Subject: CHECK ENGINE LIGHT ON WIT DTCS P0012, P0011, AND POSSIBLY P0010	Service Alert No.: SA-033/25
	Last Issued : 06/20/2025

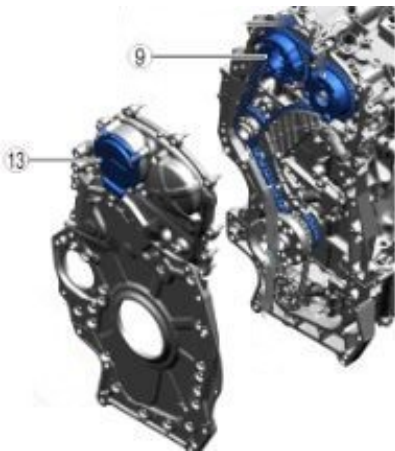
Some vehicles may experience a CHECK ENGINE light ON with DTC P0012, P0011, and possibly P0010. This may be caused by a malfunction in the intake EVVT motor that prevents it from accurately regulating the intake camshaft timing.

According to the WSM, replace the intake EVVT motor #13 with an updated EVVT motor.

NOTE: DO NOT replace the cam actuator #9.

Parts Number	Description	Qty.
T3011-24-Z0E	EVVT Motor	1
